SERVICE INFO

Change to the pulleys of a few tensioning arms for the accessory unit drive

INA 0055

Image 1: Detailed view of pulley in its previous design (left) and new design (right)

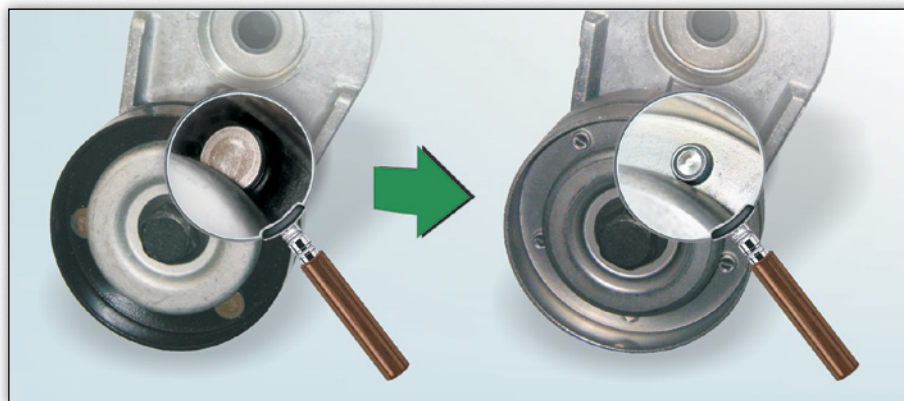
From now on, Schaeffler Automotive Aftermarket will offer versions with a modified pulley for the listed tensioning arms.

The differences are, as are shown in Image 1, the coating (previously black, now metal) and the connection between both race halves (previously riveted, now tox clinched).

During the transition period, we may have mixed stocks of both designs. Both versions meet the technical specifications and can be used without restrictions on the vehicles specified in the catalogue.
